Safety Recall

Code: 90S9

REVISION

Subject	Gateway Control Module																									
Release Date	July 22, 2022																									
REVISION SUMMARY	Added examples of incorrect gateway cover installation NOTE: Updated areas in this document are indicated by an orange bar in the right margin																									
Affected Vehicles

Cover folded under the gateway.

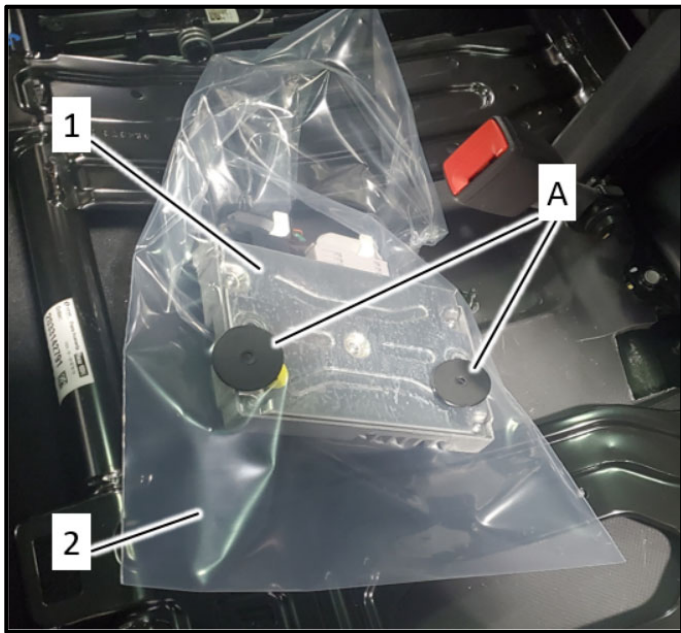
Ensure the cover is installed correctly. If the cover is folded under the gateway, it's possible to pinch the cover and create a puncture in the cover. Pay very close attention to how the cover is installed and also ensure the bolts are torqued correctly. Below are examples of covers that were not installed correctly, which can result in liquid entering the cover and damaging the gateway.

Cover pinched, resulting in puncture.

Cover folded under the gateway.

Cover pinched, resulting in puncture.
